Docket No.: 50-261

SUBJECT: NRC REQUIREMENTS FOR AUXILIARY FEEDWATER SYSTEMS AT H. B. ROBINSON STEAM ELECTRIC PLANT, UNIT 2

ENCLOSURE 1

AUXILIARY FEEDWATER SYSTEM

Auxiliary Feedwater System
 H.B. Robinson
 Figure 1.

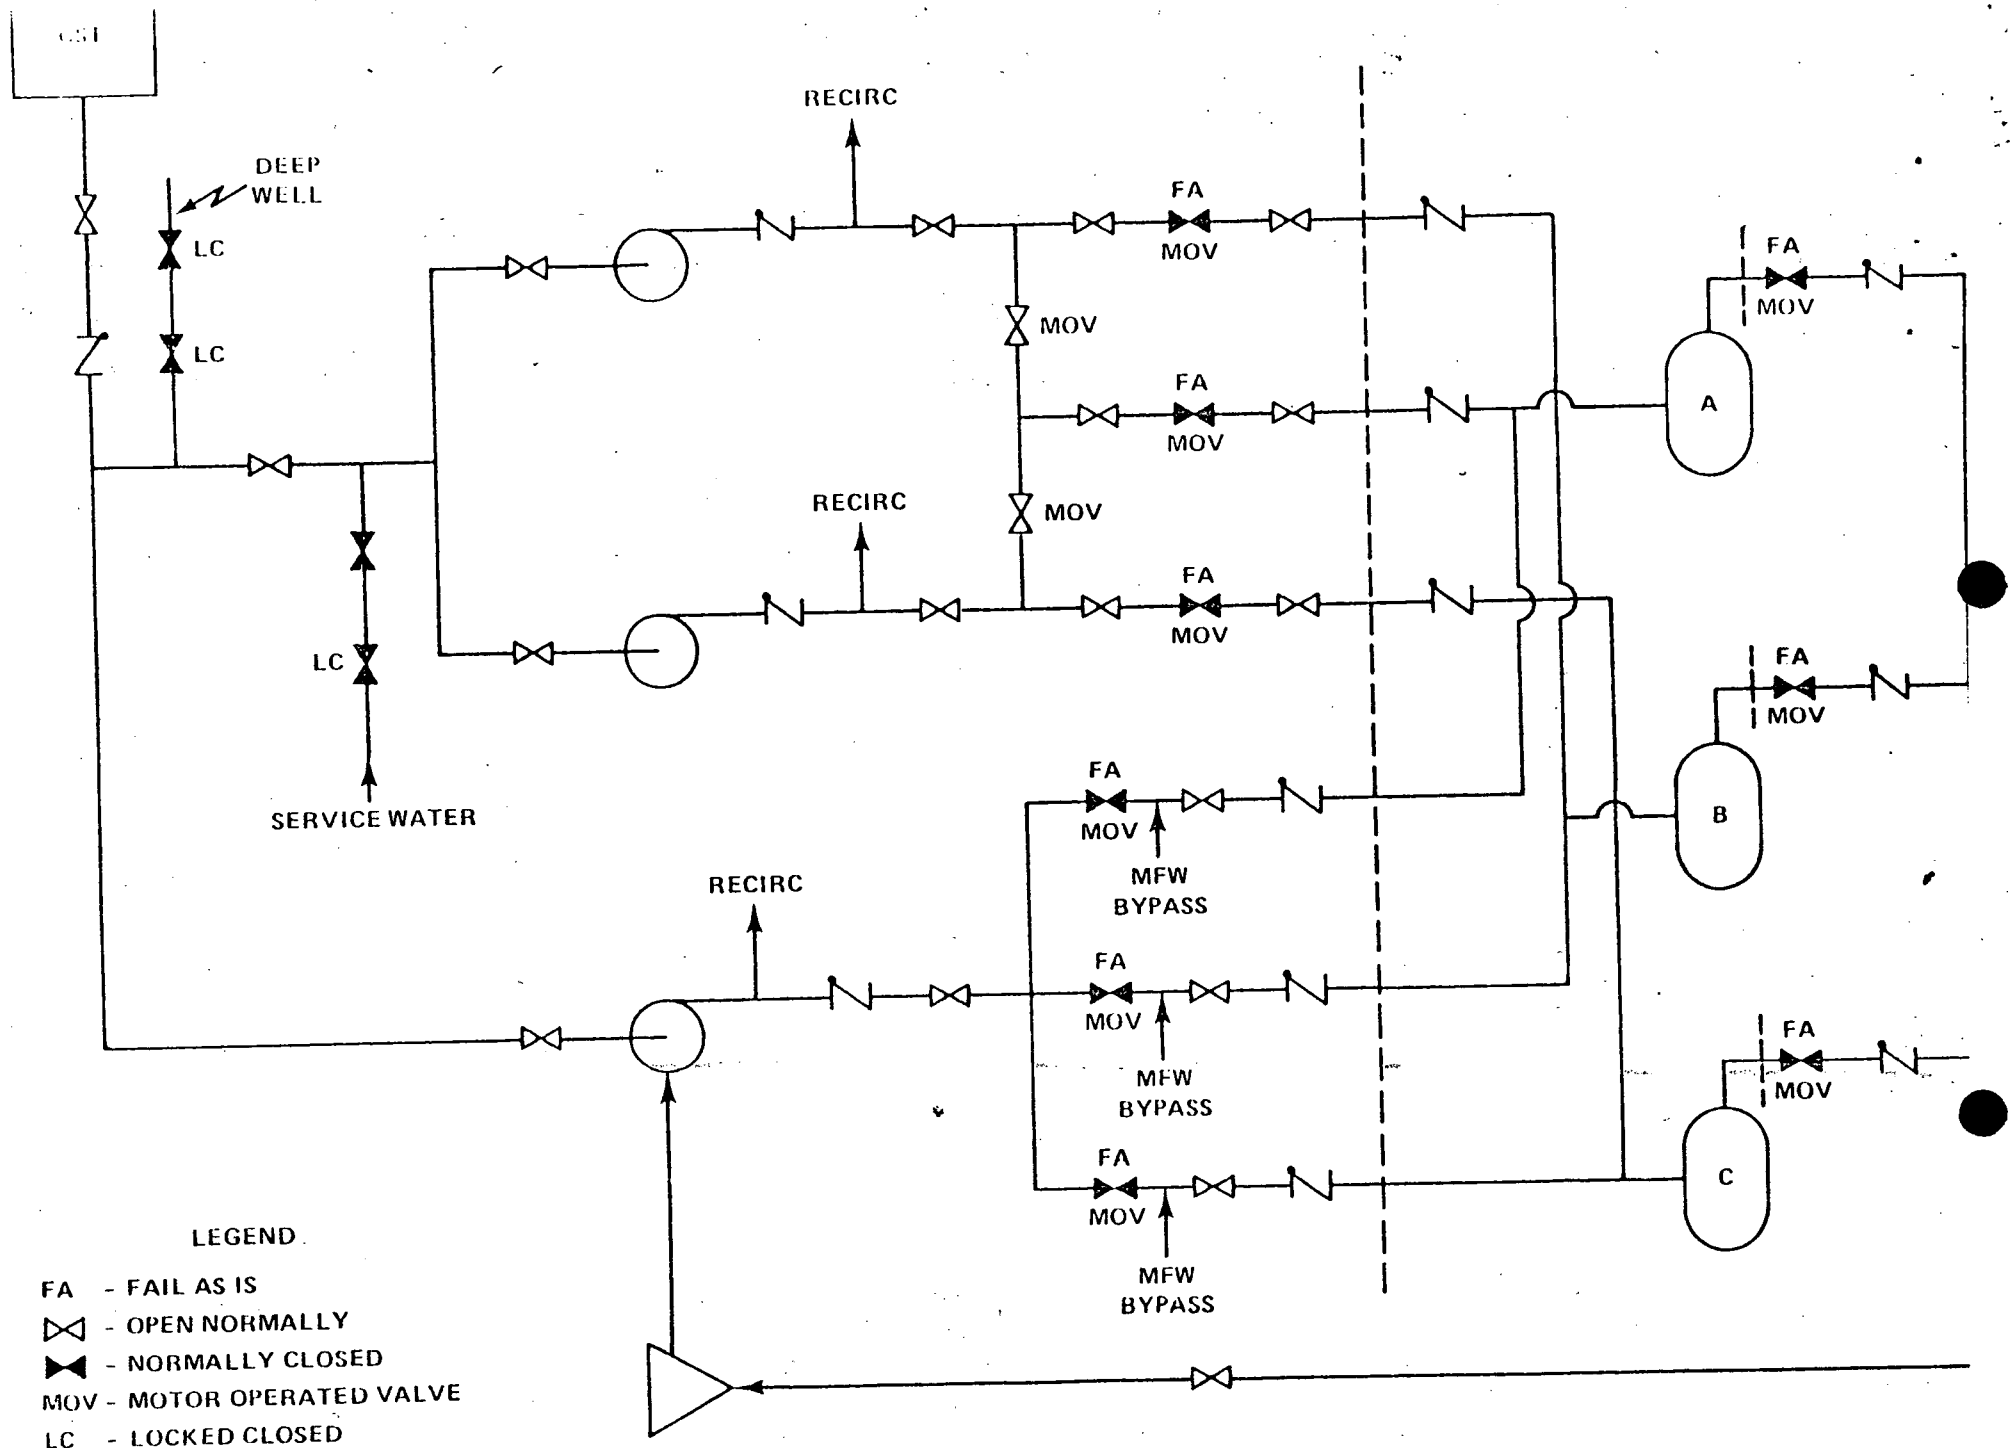
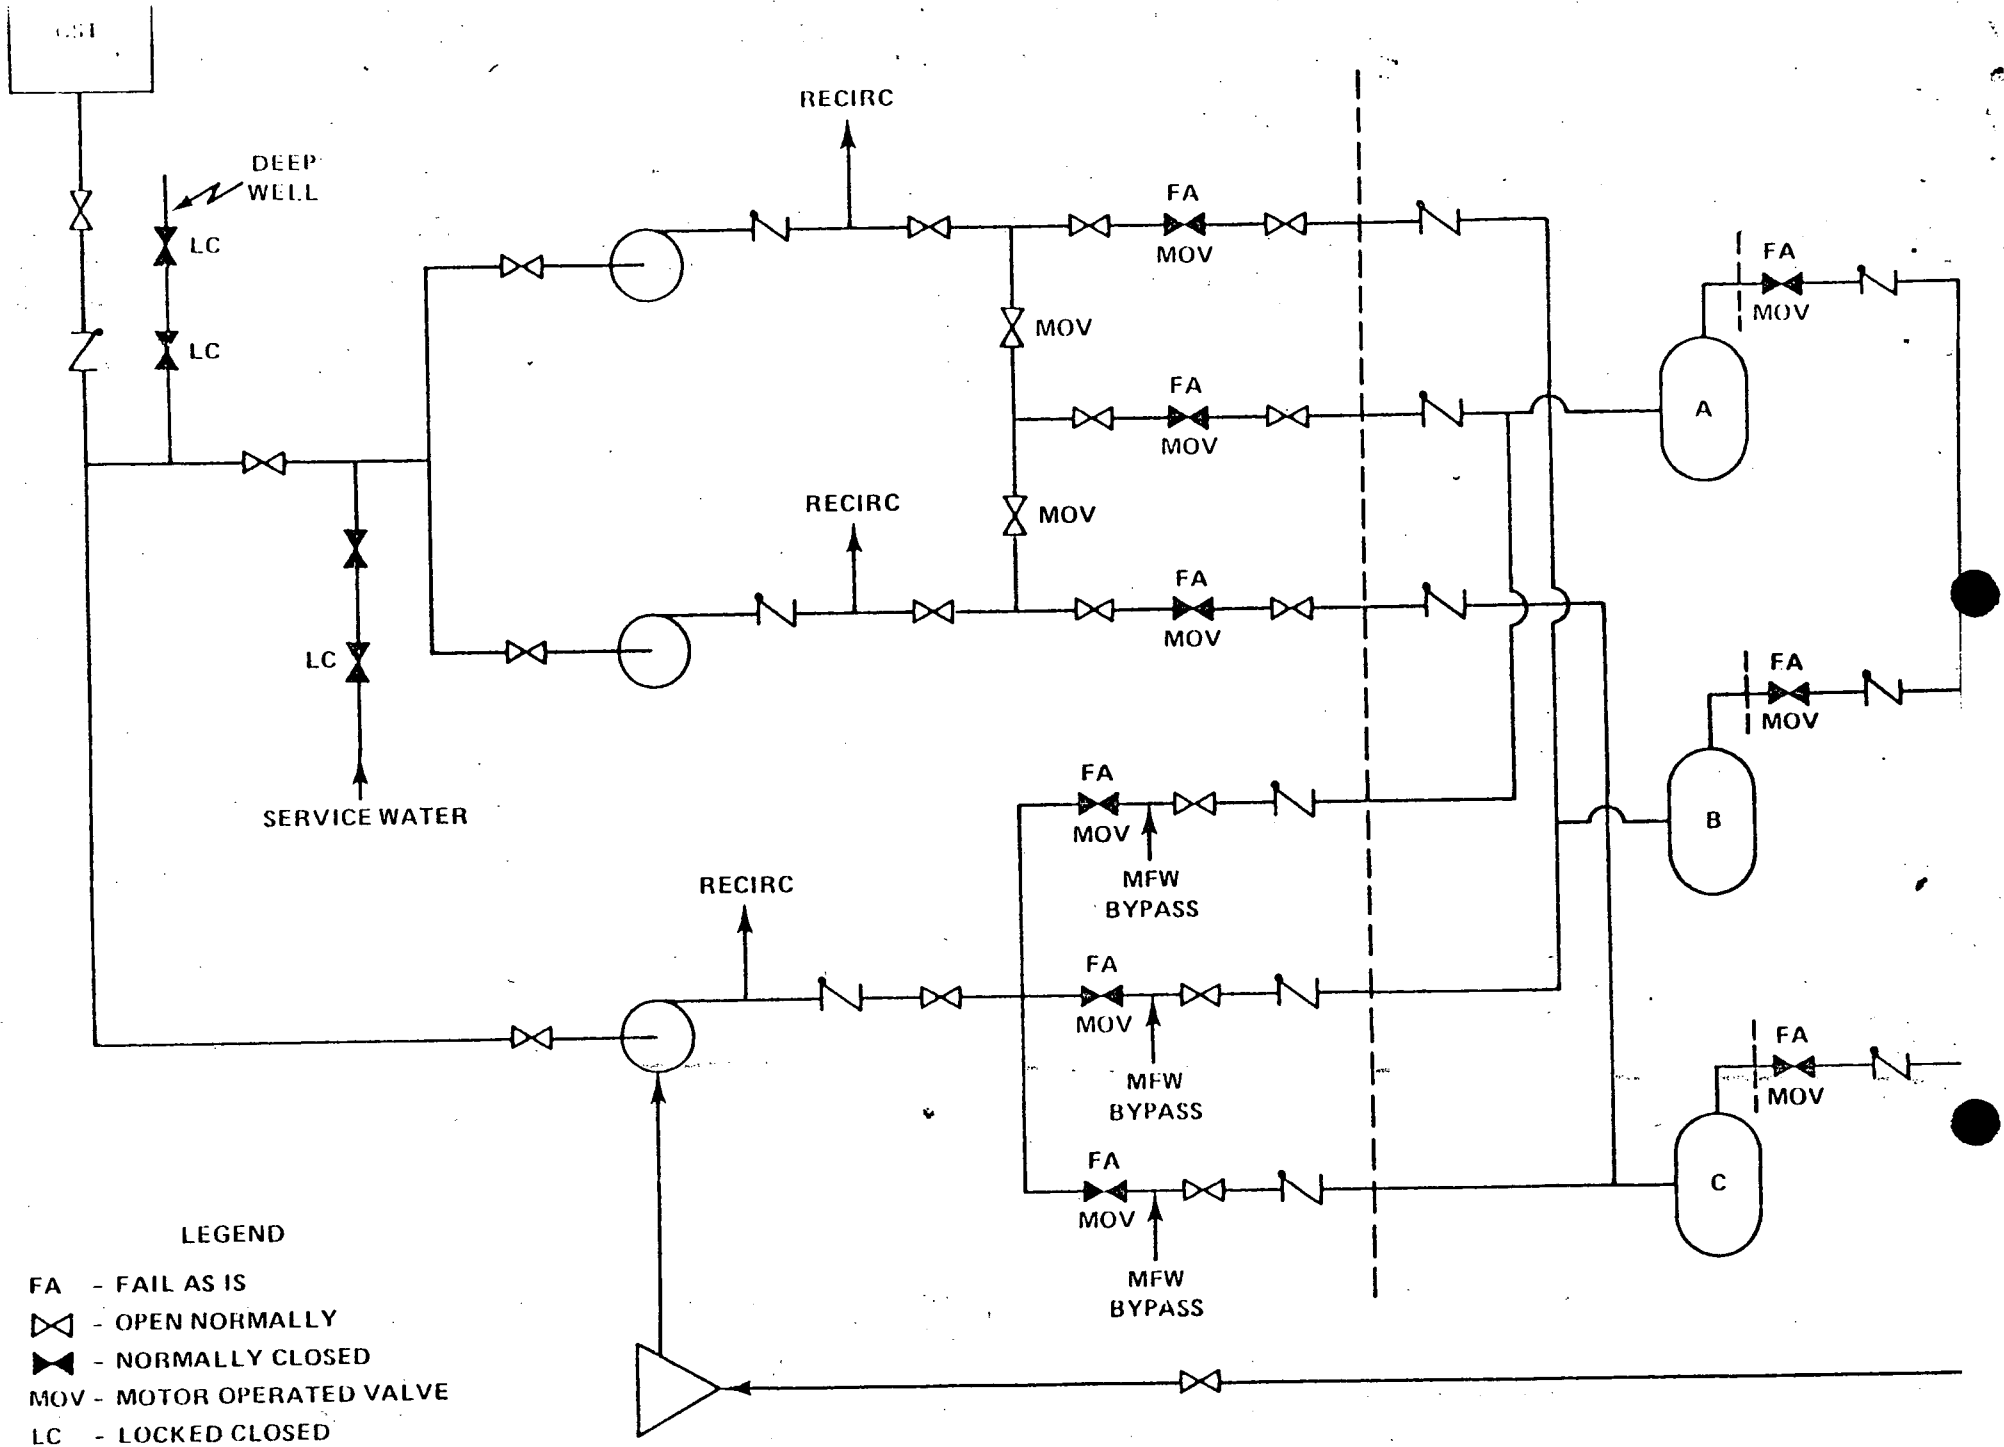
A simplified drawing of the H. B. Robinson auxiliary feedwater system (AFWS) is shown in Figure 1. Basically the system consists of two motor driven pumps located in the auxiliary building, each with a capacity of 300 gpm at 1300 psi. and a turbine driven pump located in the seismic portion of the turbine building with a capacity of 600 gpm at 1300 psi. The turbine-driven pump is not tornado missile protected. All three pumps take their primary suction from the seismic Category I condensate storage tank. The system is automatically started by signals identified in Section 6.1.4.3. The two motor driven pumps take suction from a common header and feed all three steam generators through lines which are cross-connected in the pump room as shown in Figure 1. There is a normally closed motor operated valve in each line to the steam generators. The AFWS discharge lines from the motor driven pumps connect to the main feed lines inside containment.

The system does not meet NRC's current power source diversity position with respect to the turbine driven pump train valves although manual action can be taken at the valves. (See recommendation GS-5)

2. Recommendation GS-2 - The licensee should lock open single valves or multiple valves in series in the AFW system pump suction piping and lock open other single valves or multiple valves in series that could interrupt all AFW flow. Monthly inspections should be performed to verify that these valves are locked and in the open position. These inspections should be proposed for incorporation into the surveillance requirements of the plant Technical Specifications. See Recommendation GL-2 for the longer-term resolution of this concern.

1. Recommendation GL-2 - Licensees with plants in which all (primary and alternate) water supplies to the AFW systems pass through valves in a single flow path should install redundant parallel flow paths (piping and valves).

Licensees with plants in which the primary AFW system water supply passes through valves in a single flow path, but the alternate AFW system water supplies connect to the AFW system pump suction piping downstream of the above valve(s), should install redundant valves parallel to the above valve(s) or provide automatic opening of the valve(s) from the alternate water supply upon low pump suction pressure.

4. None of the AFW water sources are protected against tornado missiles. The licensee should complete an evaluation considering a postulated tornado plus a single active failure to determine any AFW system modifications or procedures necessary to assure a sufficient AFW water supply or assure that the plant can be brought to a safe shutdown condition in such an event.
